SERVICE INFORMATION BULLETIN

NUMBER: 06-68-19

SUBJECT: Proper Grease Application during Brake Pad Installation

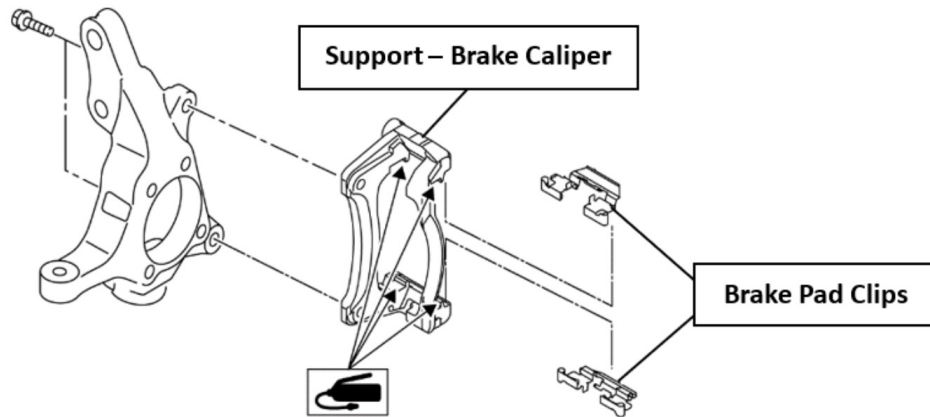
The EXAMPLE illustration shown below for reference is from a 2019MY Forester. The procedure below is applicable when replacing either FRONT or REAR brake pads.

- Before installing new brake pads, remove the pad clips and **thoroughly** clean the caliper support of any dirt, rust or corrosion, paying close attention to the areas where the clips are attached / seated.

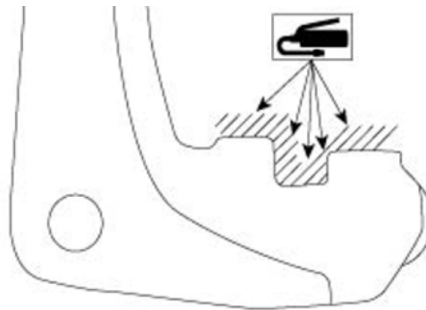
- Apply a thin coating of brake grease to the caliper support then refit the pad clips to the support.

- Apply a thin coating of brake grease to the ends of the new brake pads where they contact the pad clips.
